SUBJECT: Responds to questions raised during 831026 telcon & forwards equipment qualification summary rept.

SUSQUEHANNA STEAM ELECTRIC STATION
RESPONSE TO STAFF QUESTIONS ON
ENVIRONMENTAL QUALIFICATION
ER 100450 FILES 148, 843
PLA-1929

EQUIPMENT QUALIFICATION REPORT

EQQF NO .40B
 COMPONENT SHEET NO 2 of 2
 REV 1 DATE 10/27/83

- 3a. Loca Test Parameters

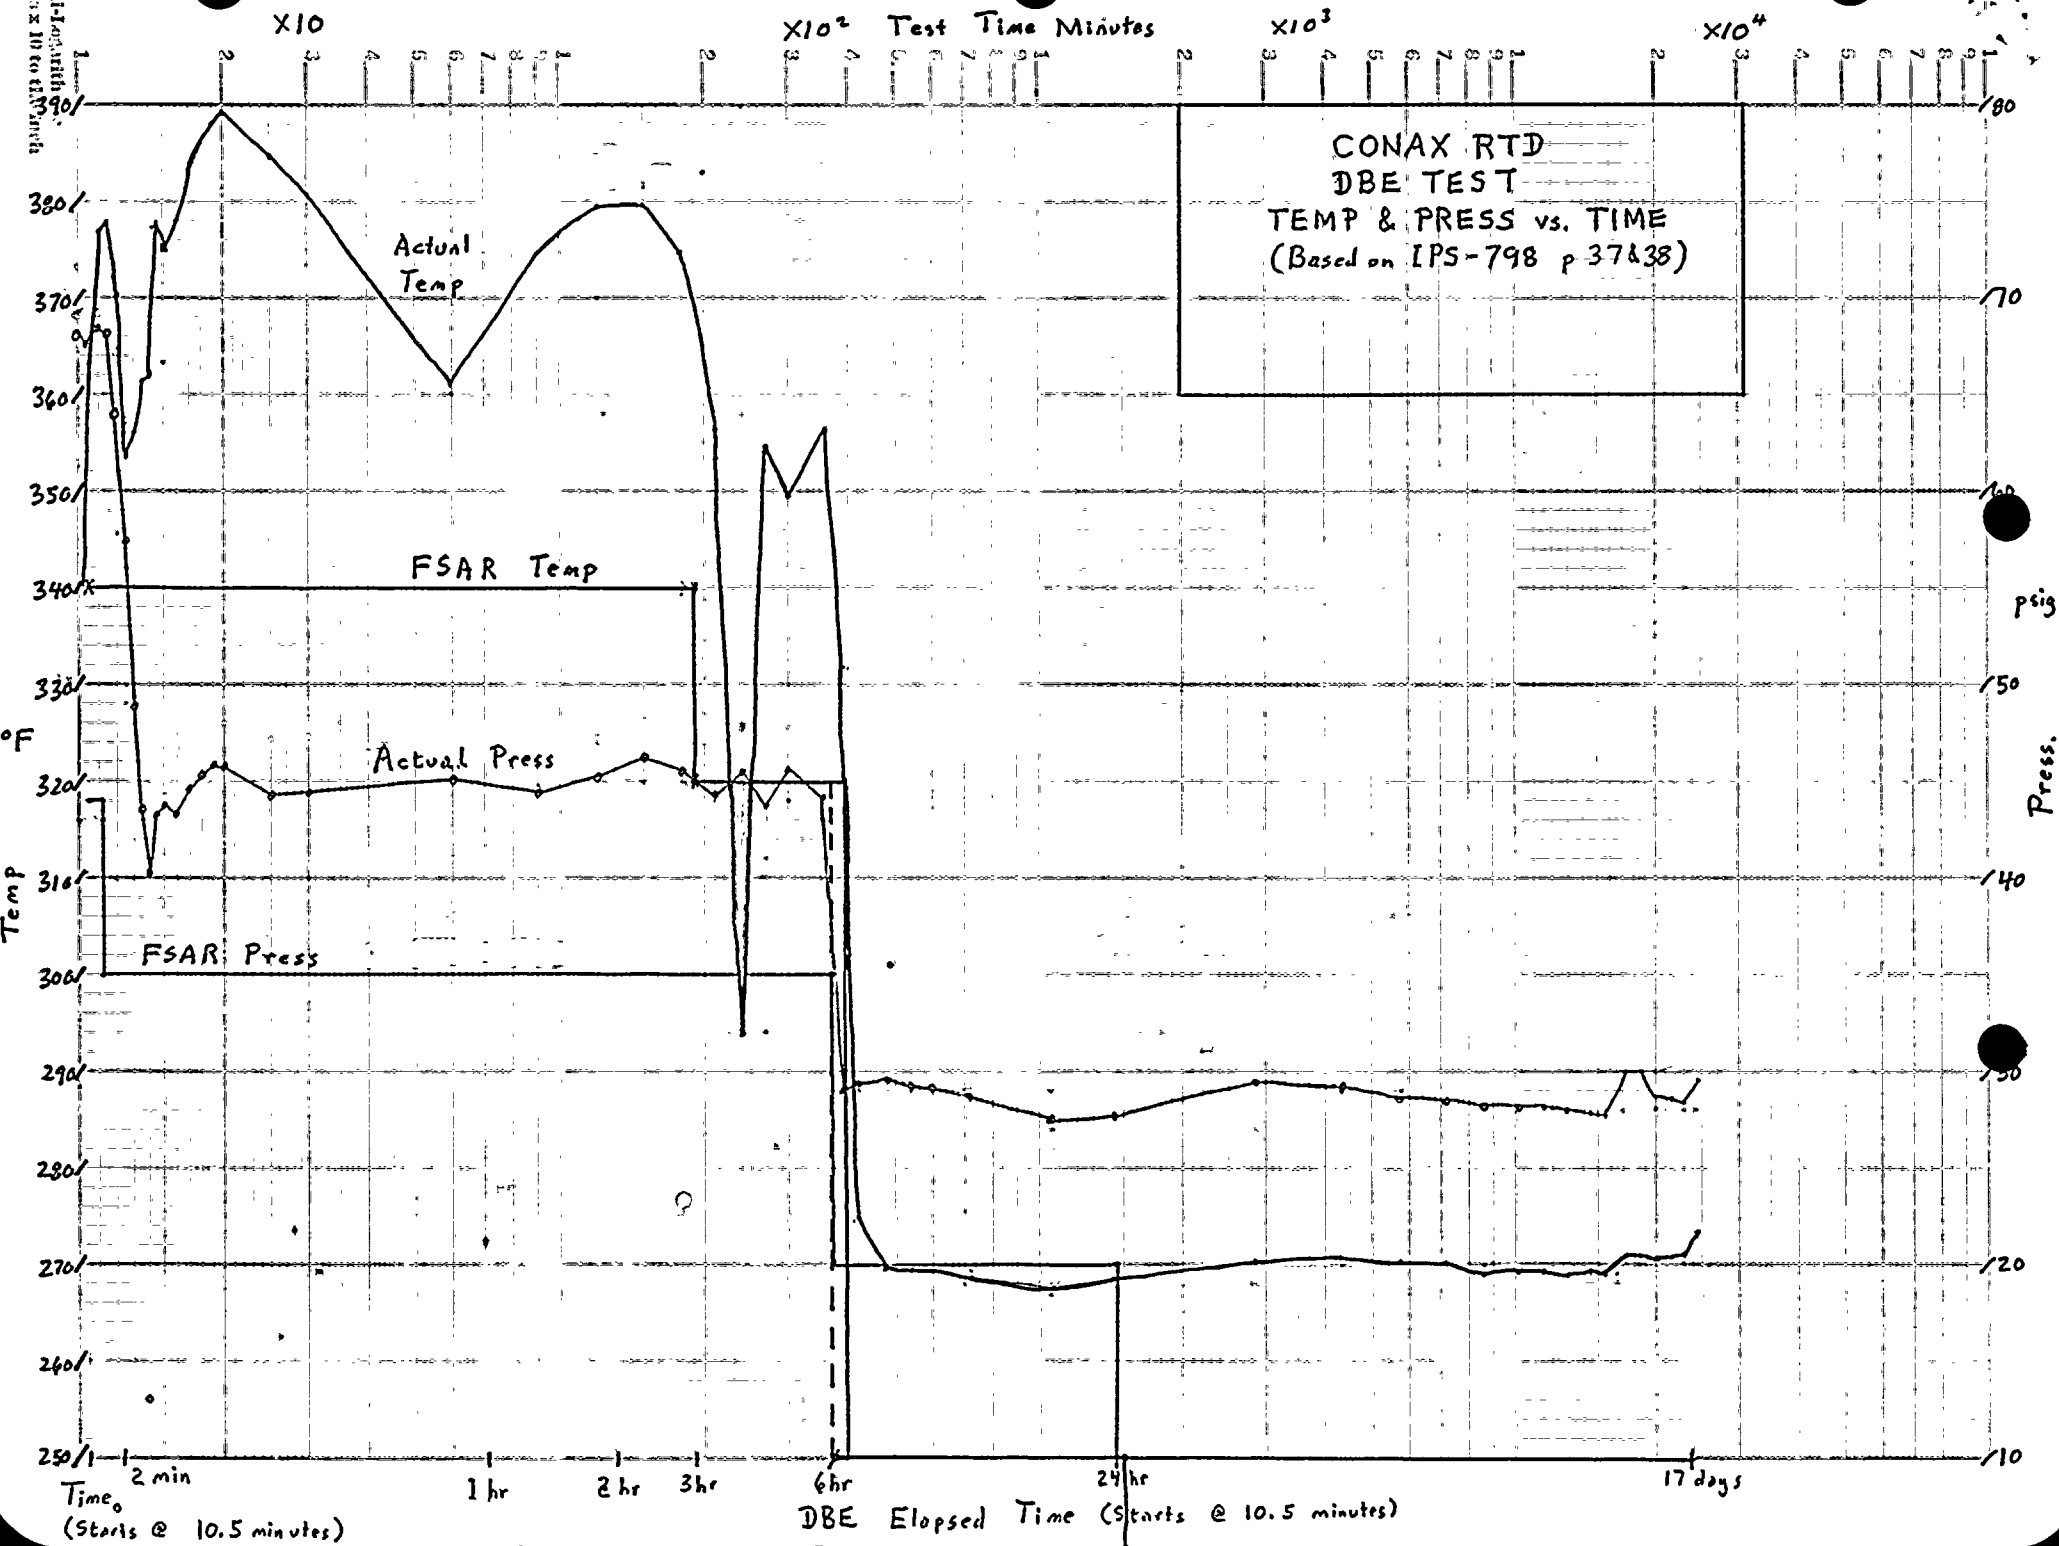
Attached find revised sheet 5D-237 of our Equipment Qualification Summary Report. Note 3a has been revised as requested. For your information, a graph is attached which depicts actual testing.

<u>Time</u>	<u>Conditions</u>	<u>Caustic Spray</u>
0-2 min.	354°F 57 psig	48 hrs
2 min-3 hrs	354°F 40 psig	
3 hrs - 6 hrs	320°F 37 psig	
6 hrs -17 days	267°F 27 psig*

*Equivalent to 552 days at 200°F per Vendor report Ref. C (IPS-798 page 7, para. 15.3.1)
